California Regional Water Quality Control Board
Santa Ana Region

STAFF REPORT

SUBJECT: Amendment of Order No. R8-2007-0003, NPDES No. CA8000326, Waste Discharge and Producer/User Reclamation Requirements for Irvine Ranch Water District, Michelson Water Reclamation Plant, Orange County – Order No. R8-2012-0004

ATTACHMENT B – LOCATION

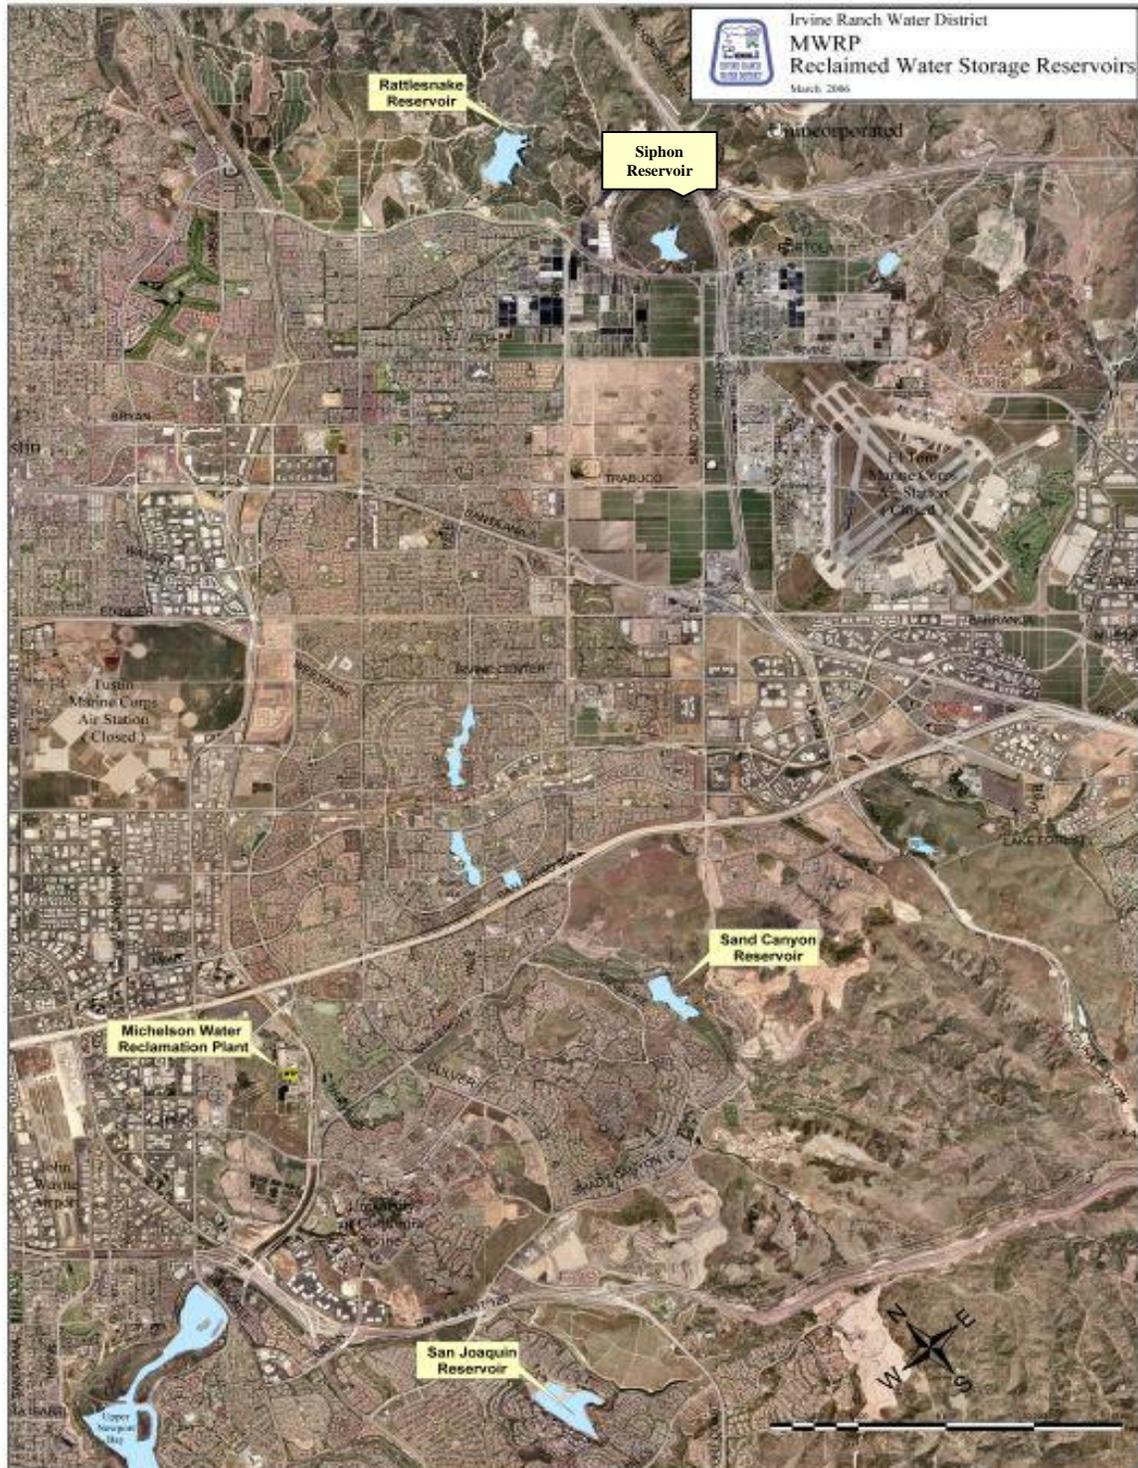
12. Attachment B, Locations, page B1, replace map of Attachment B with attached map (page 16 of this Order):
